SUBJECT: Sunnyside Mine Meeting

April 4, 1995

Settlement Flow Chart
Sunnyside Gold Corporation

RE: Discussion Items for May 17, 1995 Meeting

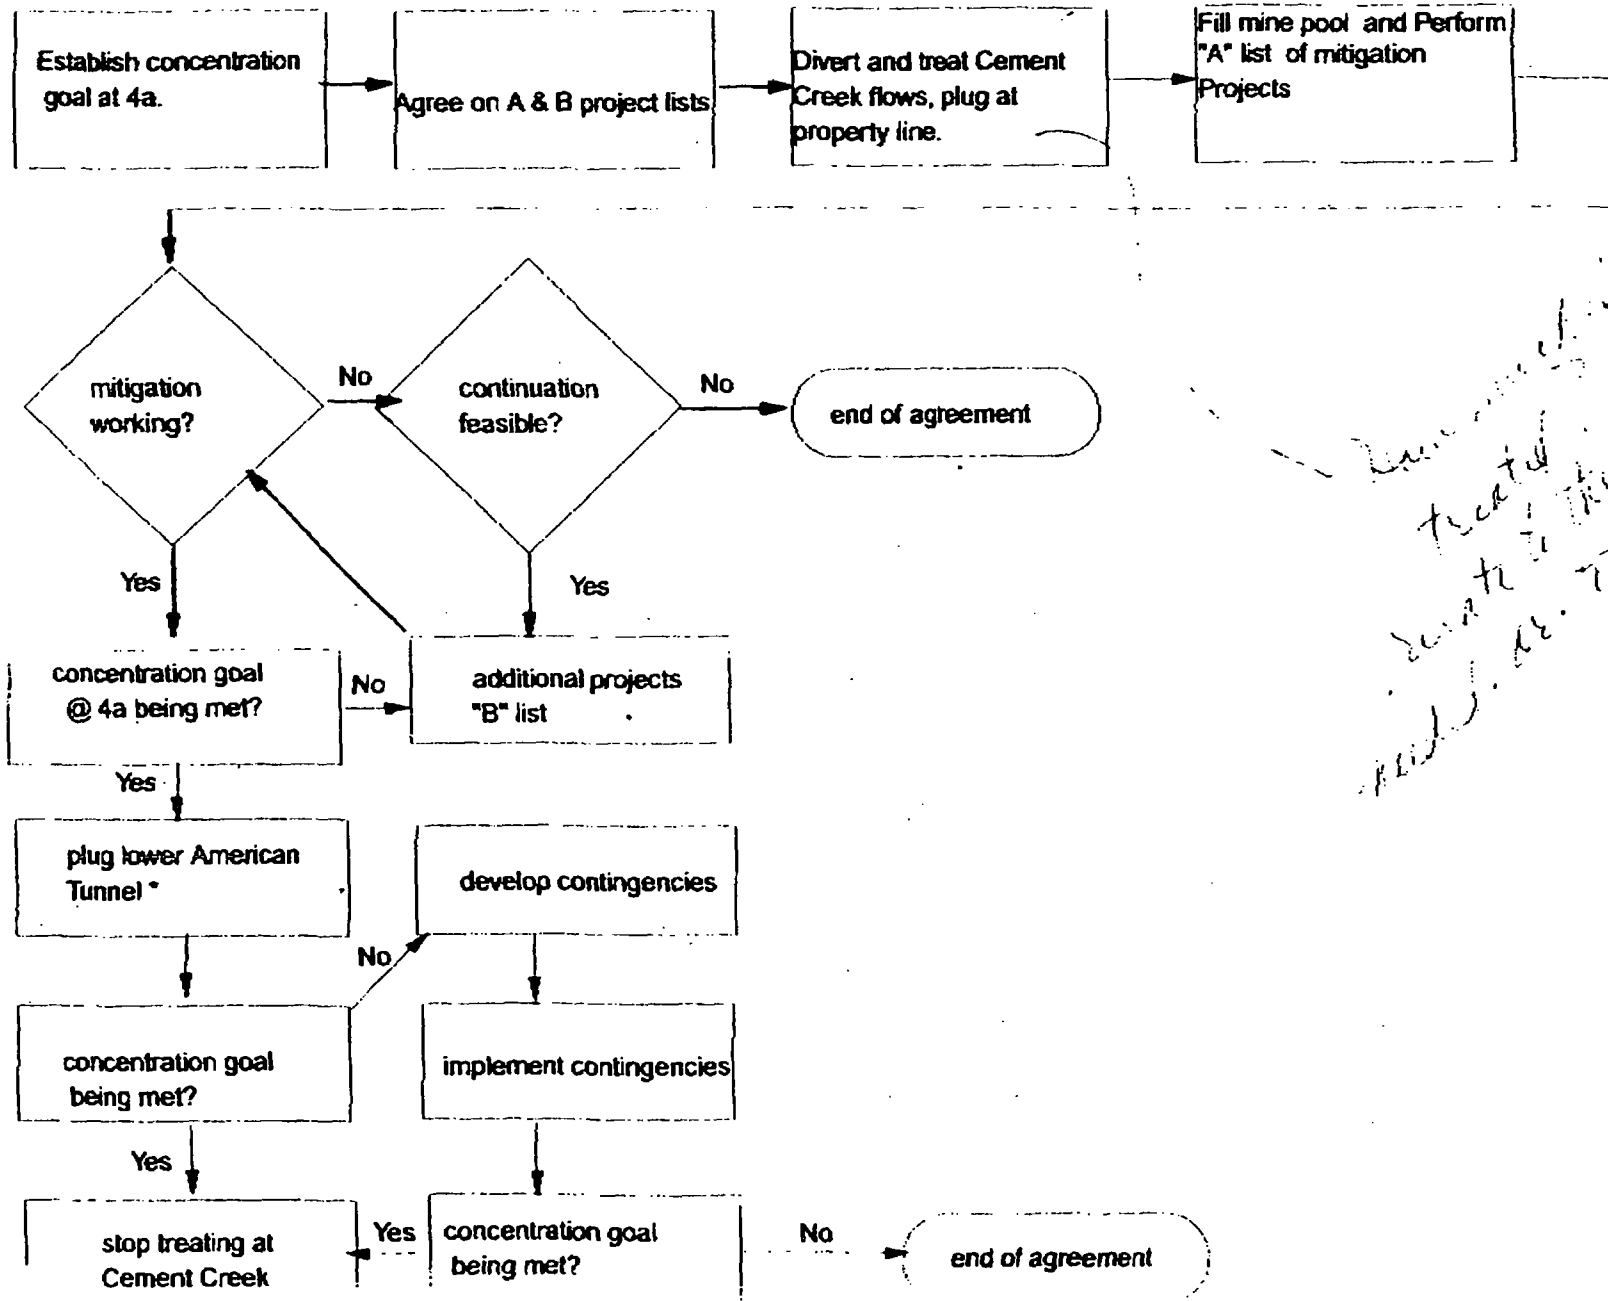
Handwritten note:
Sunnyside Gold
treated
sewer to the
fill. Dr. 7.16
sludge
